UNITED STATES PATENT AND TRADEMARK OFFICE

APPLICATION NO.	FILING DATE	FIRST NAMED INVENTOR	ATTORNEY DOCKET NO.	CONFIRMATION NO.
10/579,721	05/17/2006	Seiji Omura	062525	3556
38834 7590 05/02/2007 WESTERMAN, HATTORI, DANIELS & ADRIAN, LLP 1250 CONNECTICUT AVENUE, NW SUITE 700 WASHINGTON, DC 20036			EXAMINER THOMAS, ERIC W	
			ART UNIT 2831	PAPER NUMBER
			MAIL DATE 05/02/2007	DELIVERY MODE PAPER

Office Action Summary

FIG. 2

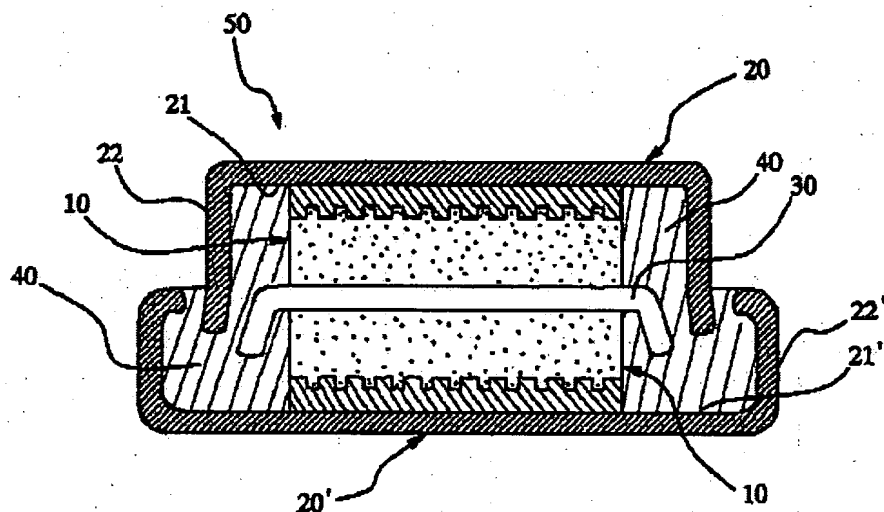
Kwon et al. disclose in fig. 2, An electric double layer capacitor, comprising:
a separator (30); a pair of polarizing electrodes (10), disposed opposite to each other

with the separator interposed therebetween; an electrolytic solution, impregnated in the pair of the polarizing electrodes and the separator;

an exterior cover (20) and an exterior case (20'), accommodating the separator, the pair of the polarizing electrodes and the electrolytic solution;

and a gasket (40), disposed between the outer circumferential part of the exterior cover and the inner circumferential part of the exterior case, storage space formed by the exterior case and the exterior cover being hermetically sealed by inwardly bending the opening tip portion of the exterior case; wherein no folded-back part is provided at the outer circumferential part of the exterior cover.

Kwon et al. disclose the claimed invention except for the gasket is formed from polyether ether ketone.

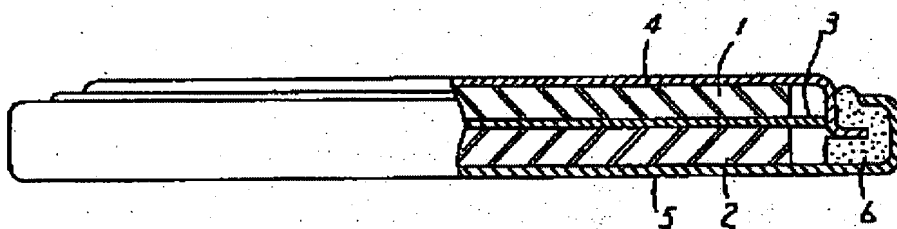
'202 teaches that gaskets formed from polyether ether ketone are excellent in heat resistance.

It would have been obvious to a person of ordinary skill in the art at the time the invention was made to form the gasket of Kwon et al. using polyether ether ketone as taught by '202, since such a modification would produce a capacitor having heat resistant gaskets.
